EPA Evaluation of the Glynn-50 Device Under
Section 511 of the Motor Vehicle Information
and Cost Savings Act

August 1981

Test and Evaluation Branch
Emission Control Technology Division
Office of Mobile Source Air Pollution Control
U.S. Environmental Protection Agency

EPA Evaluation of the "Glynn-50" Device under Section 511 of the Motor Vehicle Information and Cost Savings Act

Sketch "A"

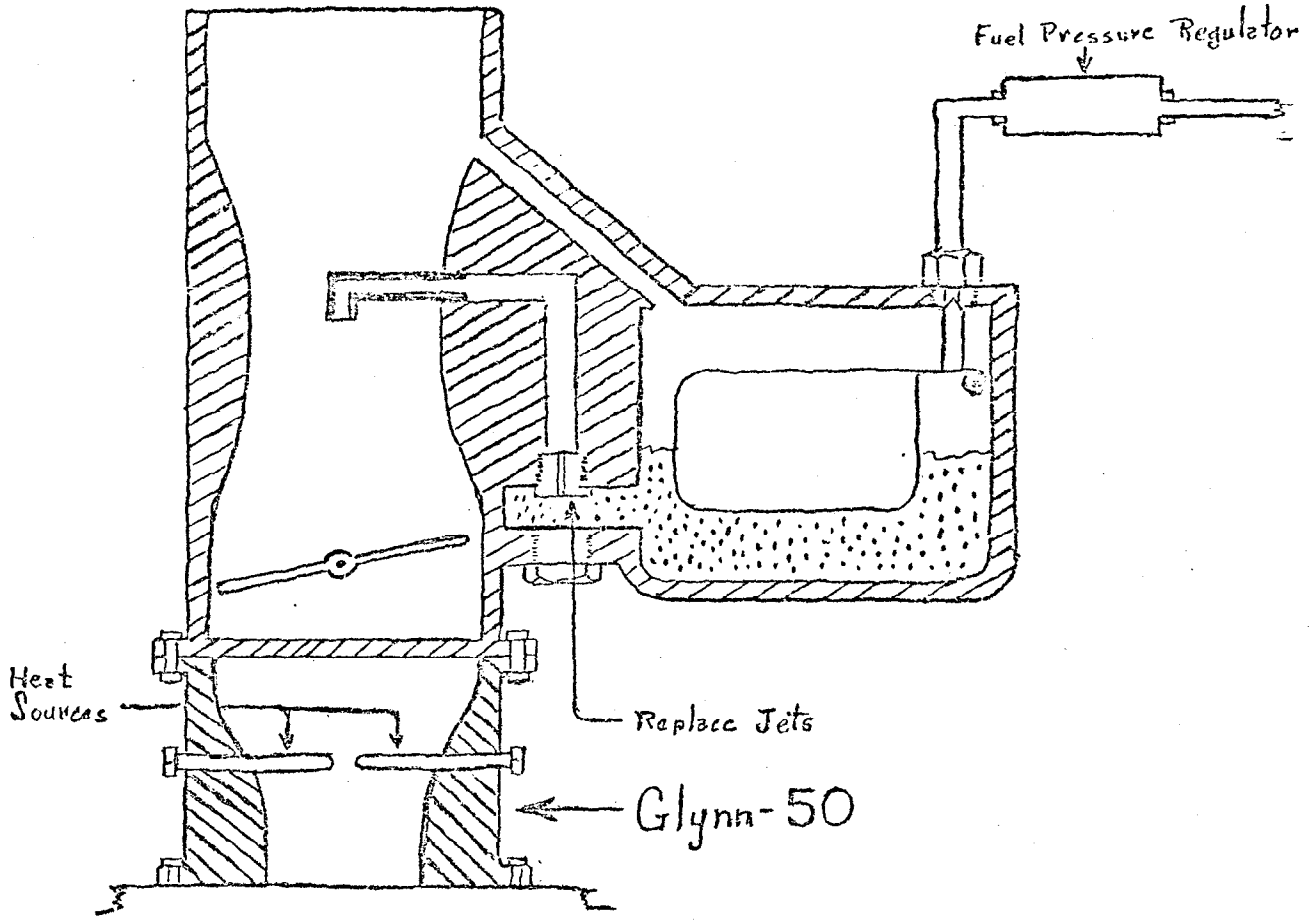
The device is judged to be inadequately described. A brief description is contained under Section 8, Description of Device, of the application (Attachment B).

1. Section No. 8(c) does not provide sufficient descriptive information for the following parameters.
 - a. Fuel pressure regulator: Does one size/design apply to all engines?

- b. Fuel metering jets: Does one size/design fit all carburetors? How much is the diameter of the jet reduced?
 - c. Venturi: Does one size/design fit all engines? How much is the inside diameter of the venturi throat reduced?

- d. Heat source: Does one size/design fit all engines? What is the method of operation (e.g. electric, exhaust gas, etc.)? Is the heat source operating continuously or intermittently? If electric, what is/are the power rating(s)? Is data available which would show the change in temperature of the air-fuel mixture as a result of the heat source? If so, please provide such data.
